ZAYO'S PRINEVILLE TO RENO PROJECT

CPUC MINOR PROJECT REFINEMENT FORM

Date Requested: 15 Oct 2024 submitted to CPUC on October 21, 2024	Report No.: 5
Date Approved: 10/25/2024	Approval Agency: Caltrans, in addition to CPUC
Property Owner(s): Caltrans (State Route 395 ROW)	Location/Milepost: PM M-29.7 to M-32.5 (S to N)
Land Use/Vegetative Cover: Ruderal (maintained highway shoulder near edge of pavement)	Sensitive Resources: Waterways at culverts to be avoided by boring underneath culverts. Cultural resources will still need to be avoided. (See project webmap.)

SHEET NO.: 64 OF 94

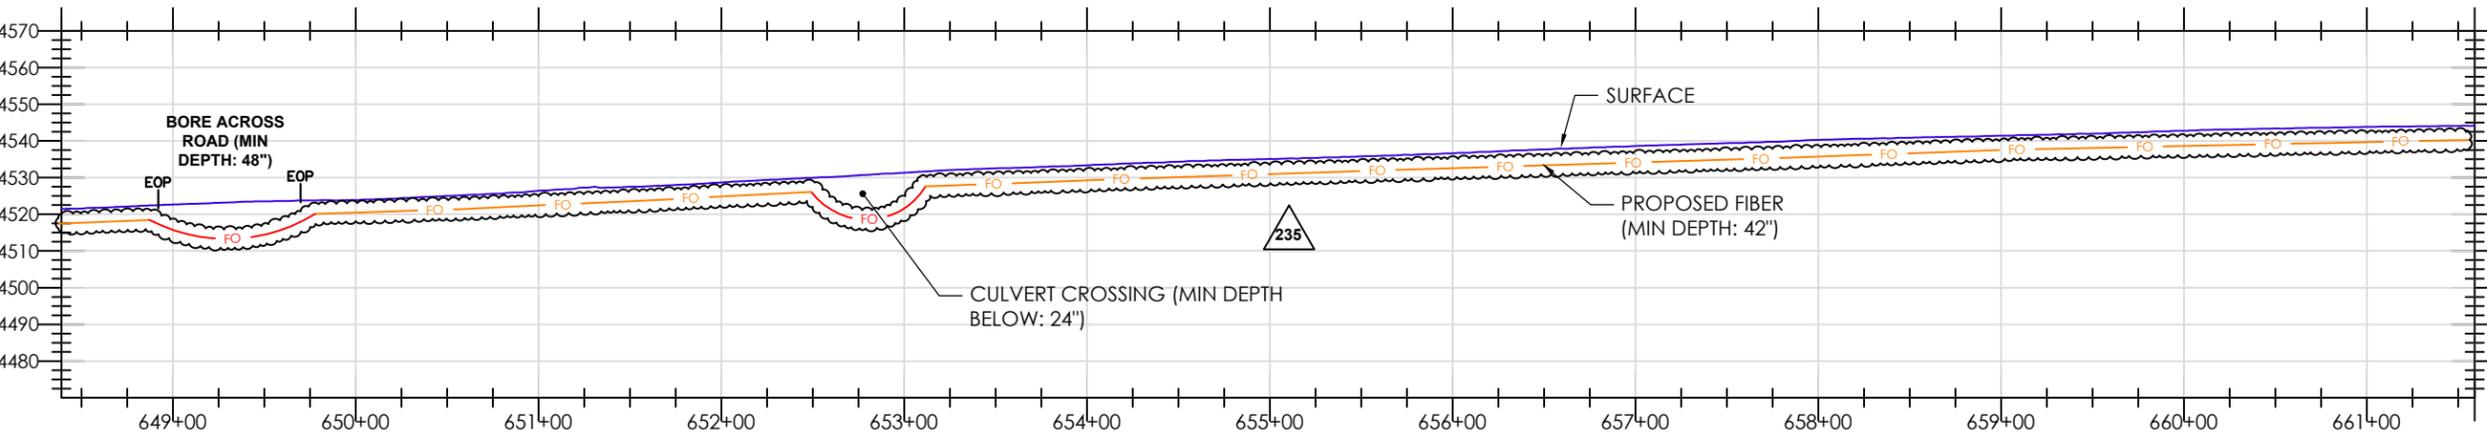
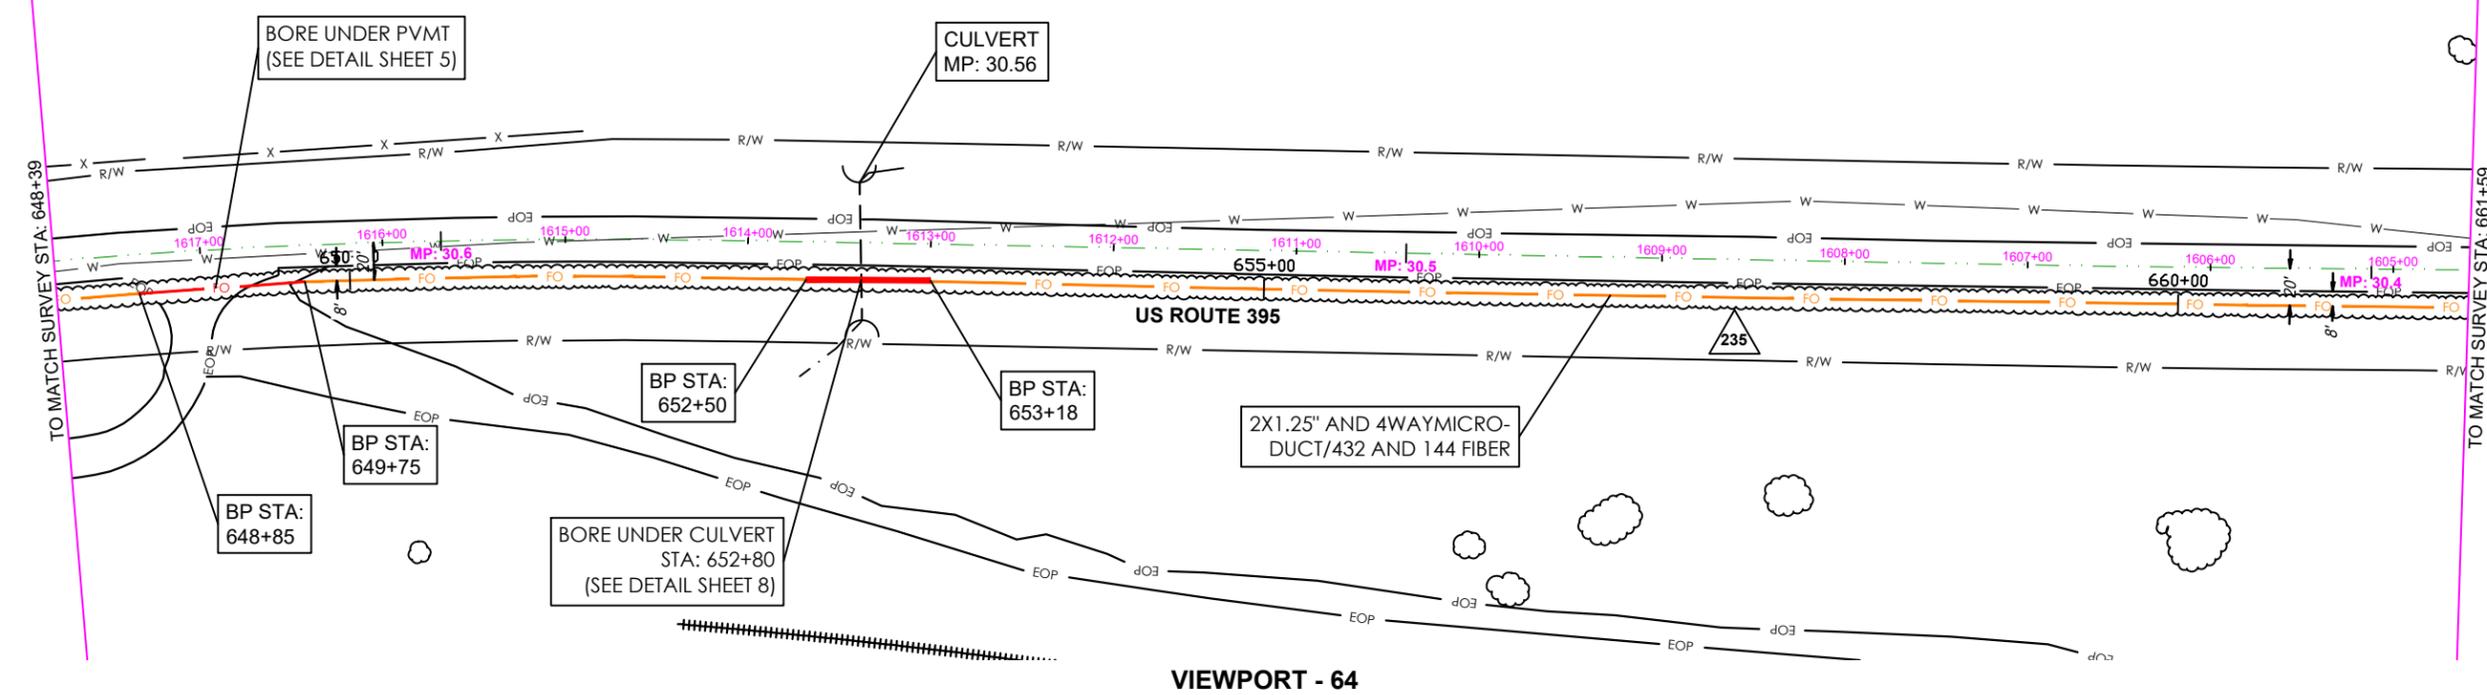
RFI NO. 0235
KEEP R/L ON WEST SIDE
8 FEET FROM EOP
STA 619+90 TO STA 701+17

SHEET NO.: 65 OF 94

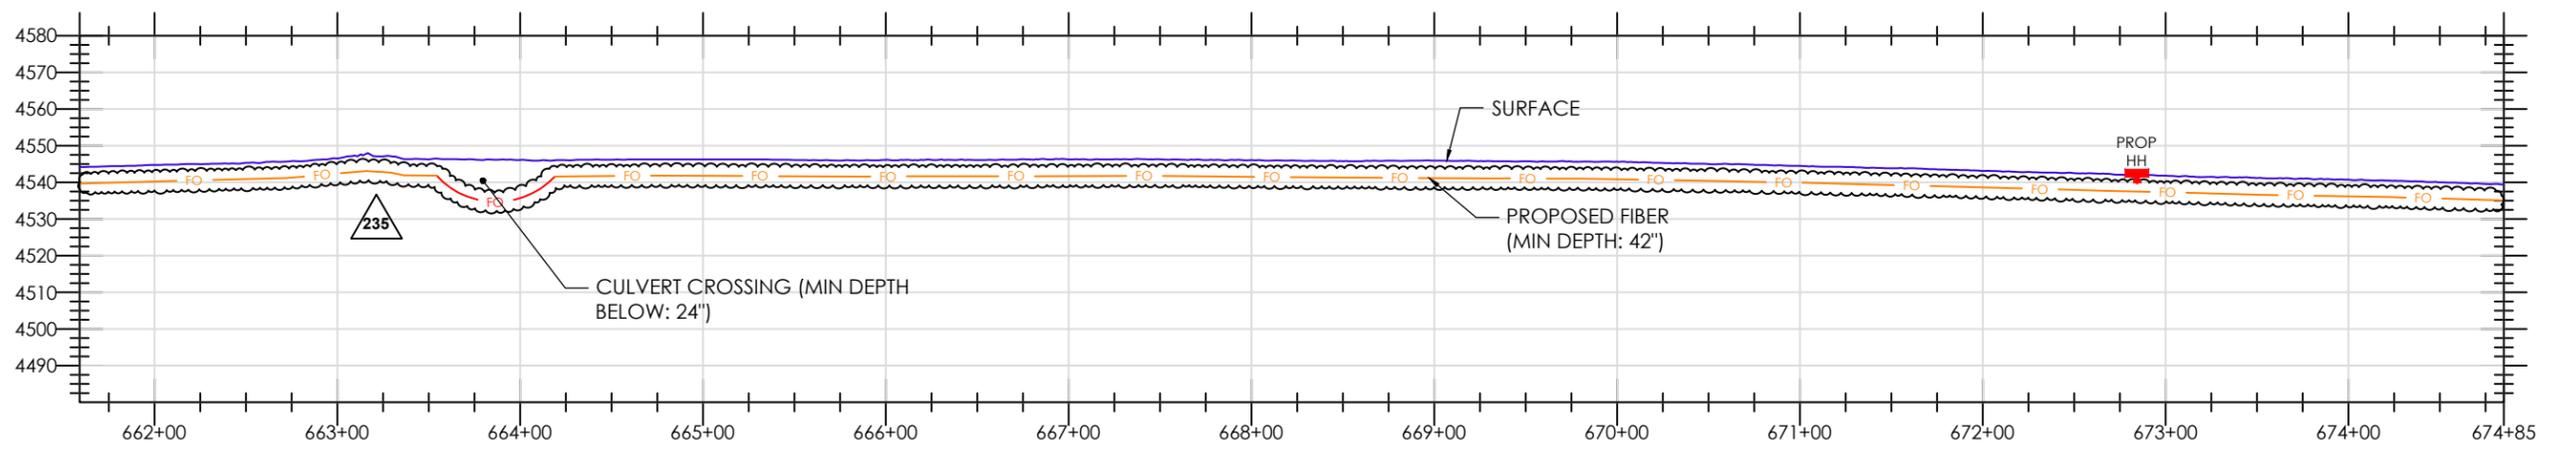
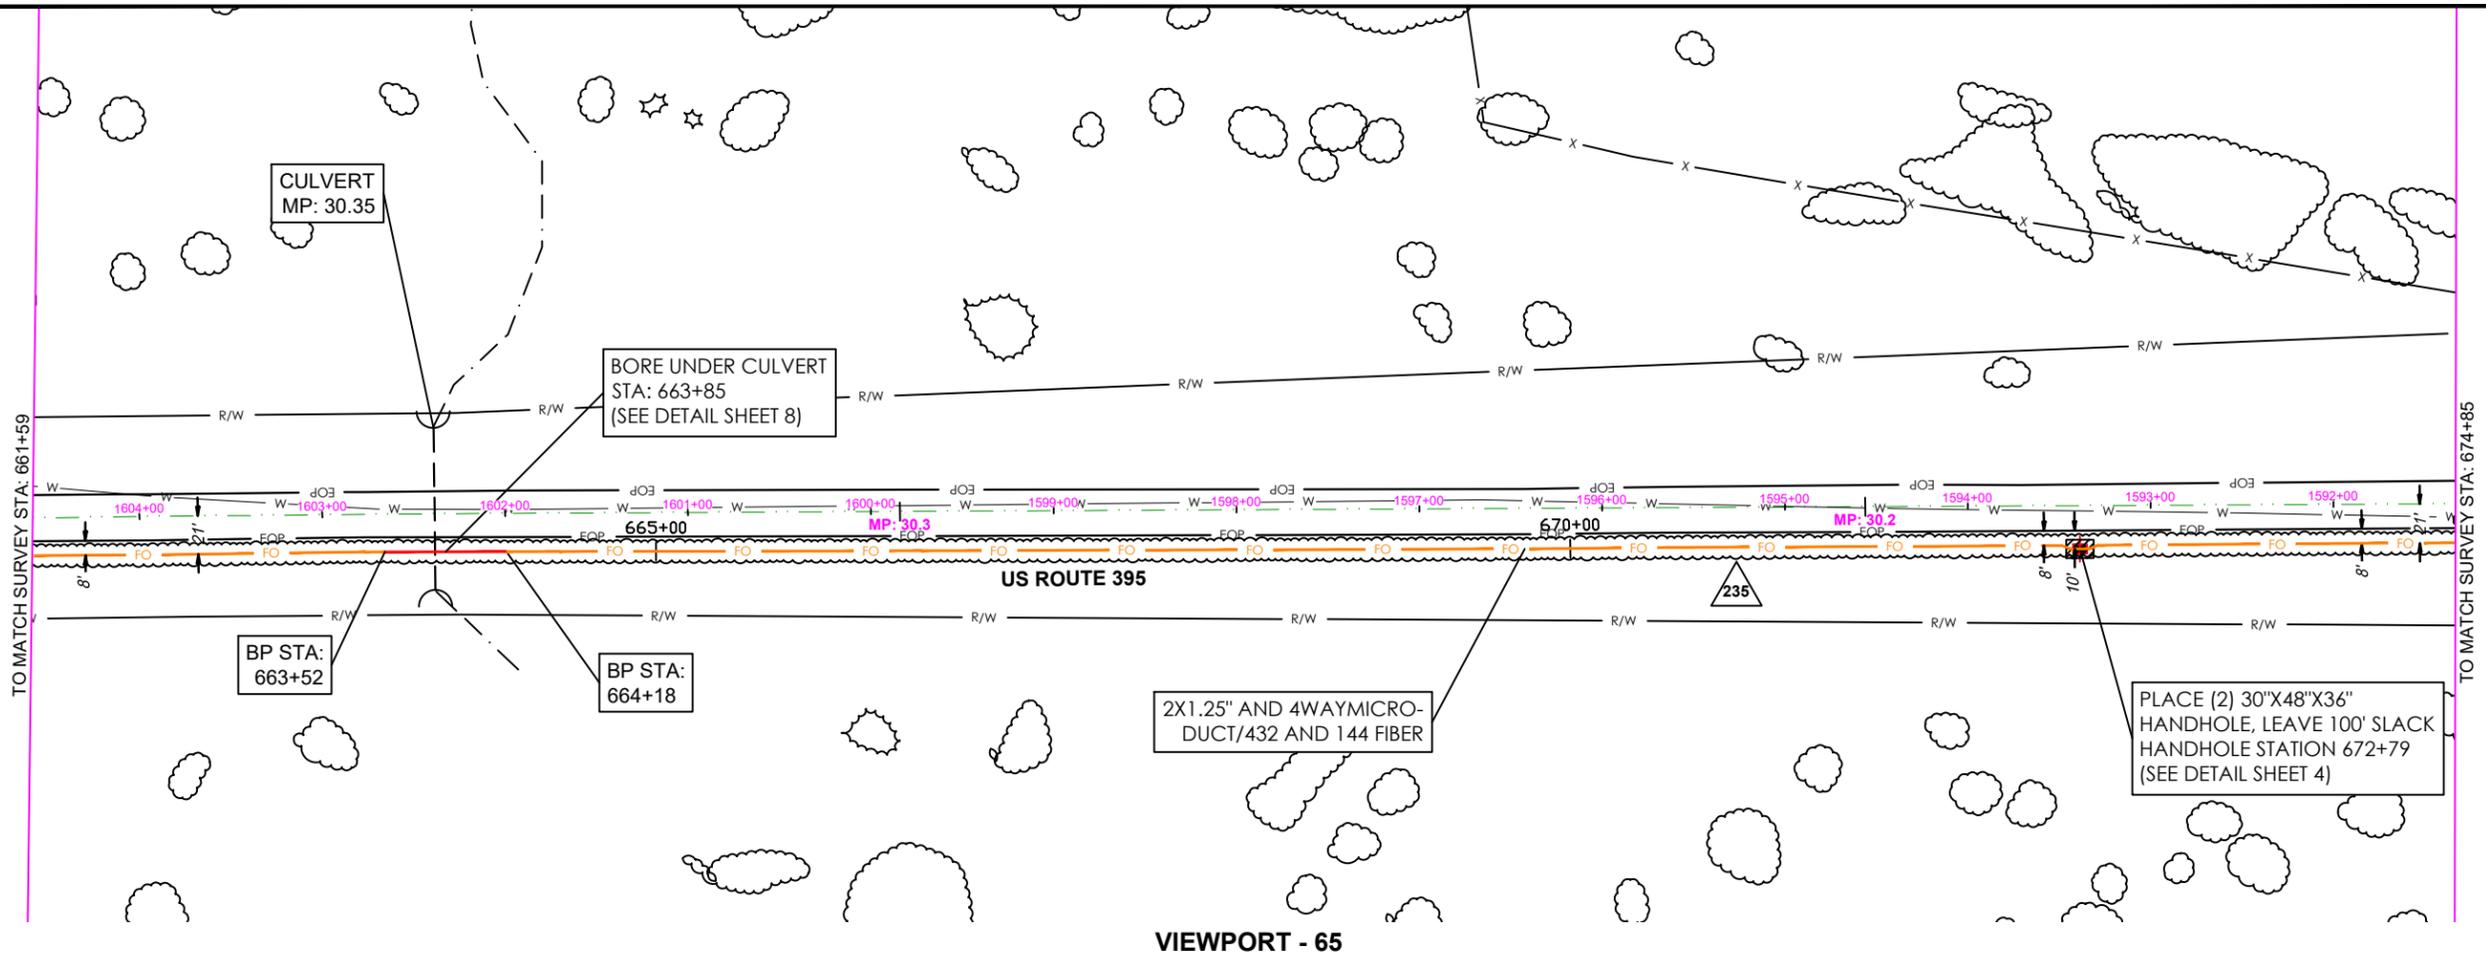
RFI NO. 0235
KEEP R/L ON WEST SIDE
8 FEET FROM EOP
STA 619+90 TO STA 701+17

SHEET NO.: 66 OF 94

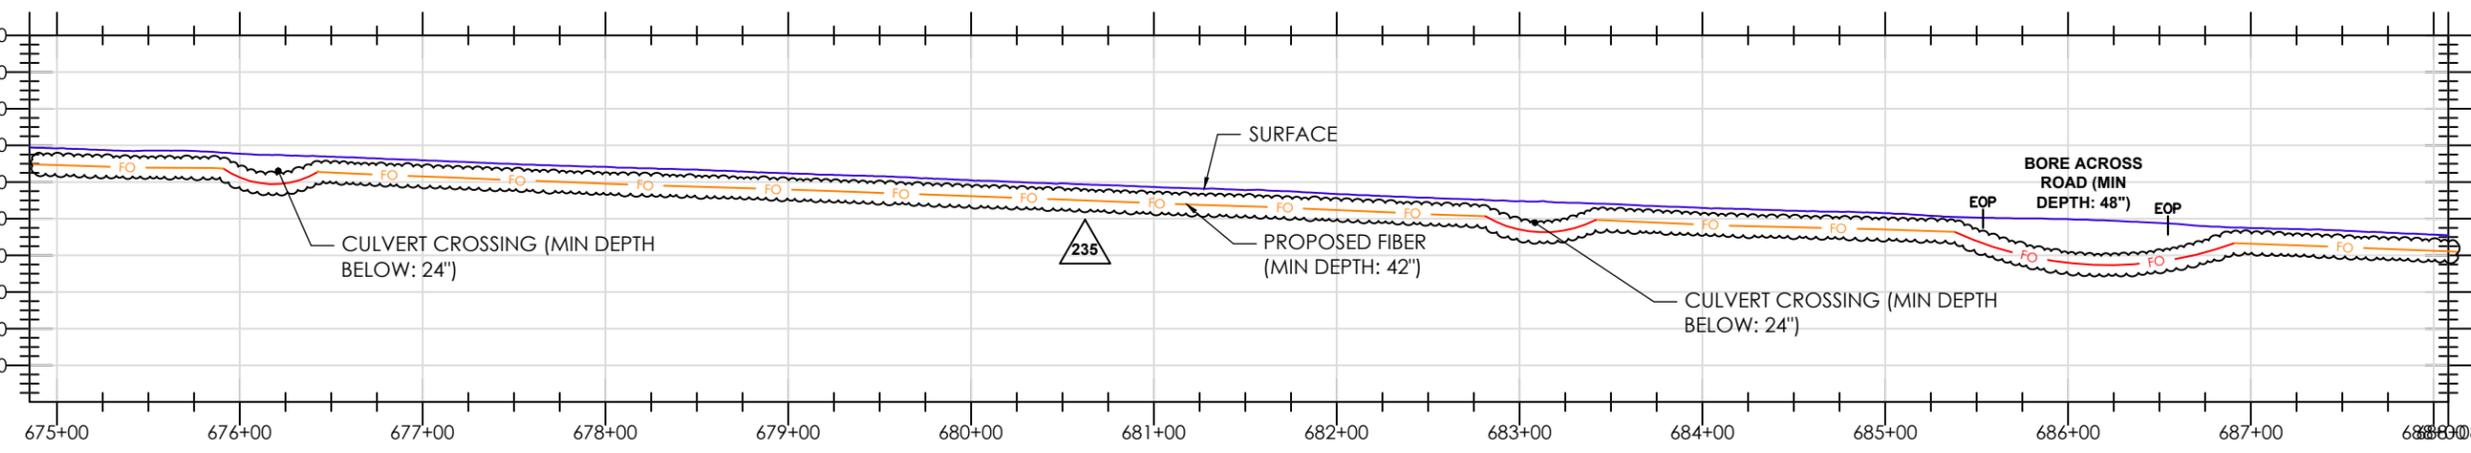
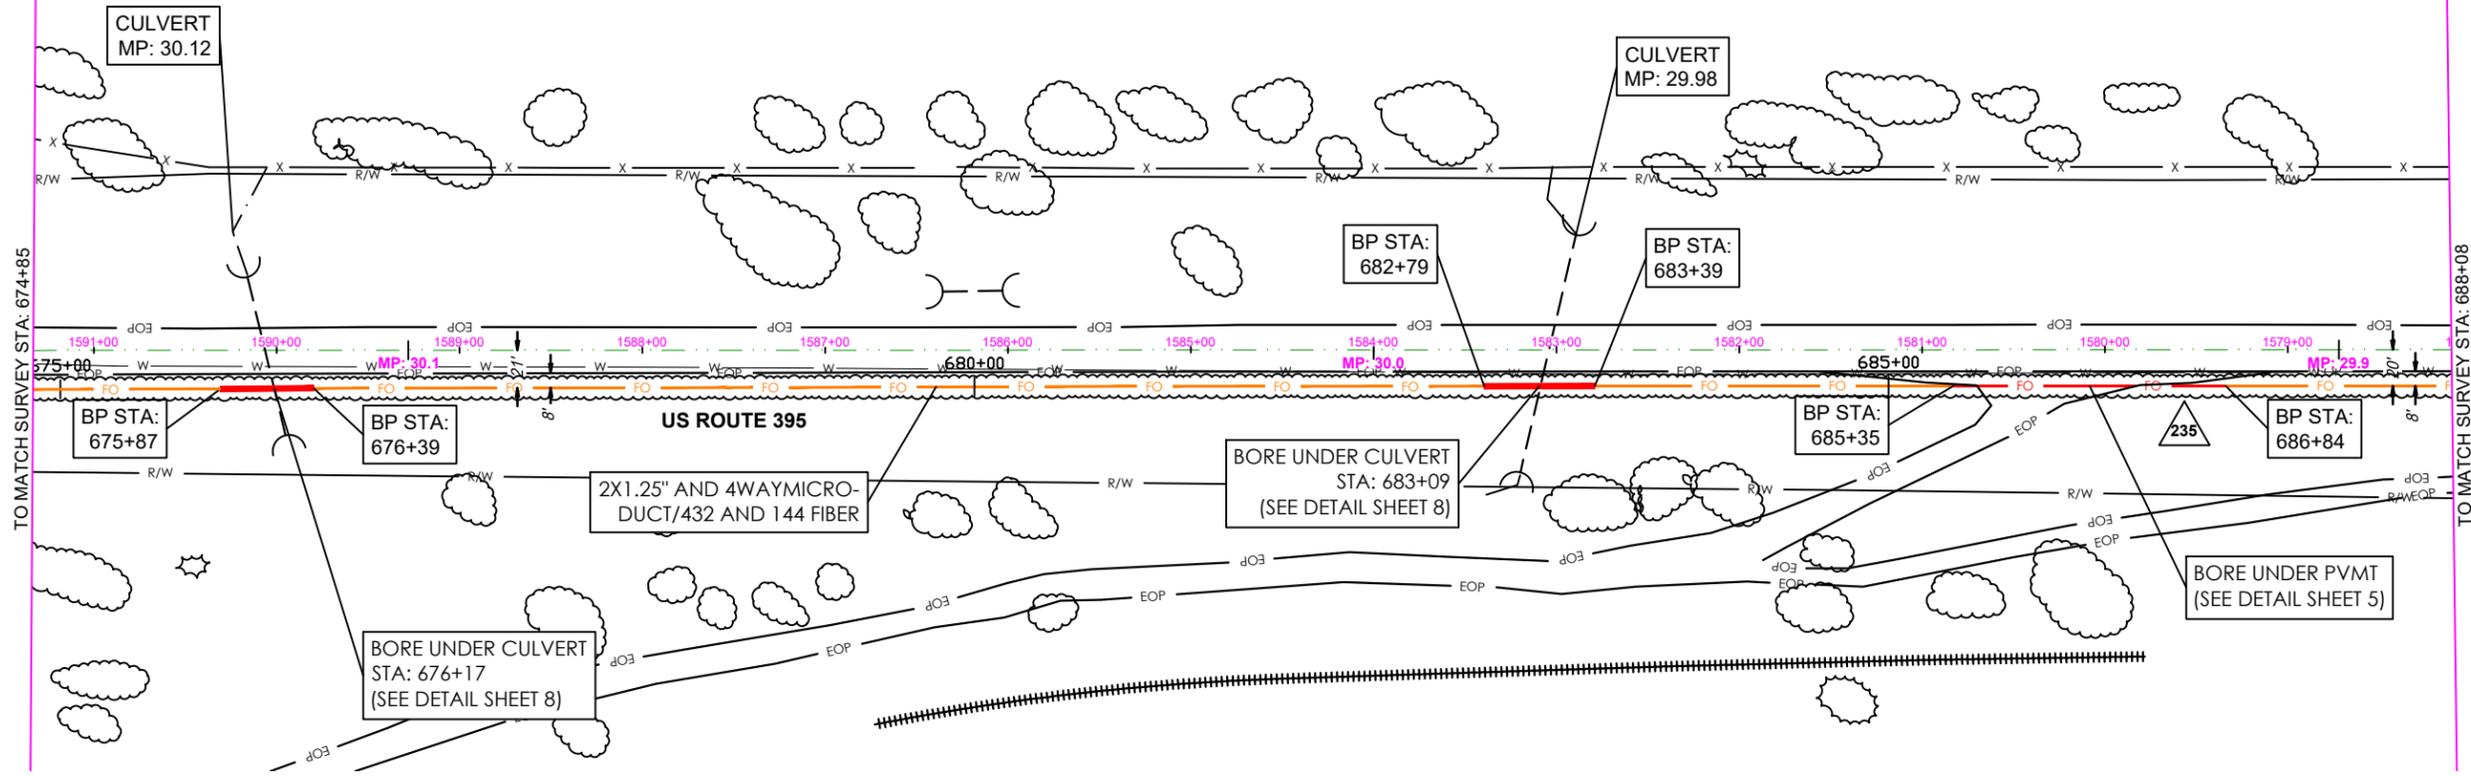
RFI NO. 0235
KEEP R/L ON WEST SIDE
8 FEET FROM EOP
STA 619+90 TO STA 701+17
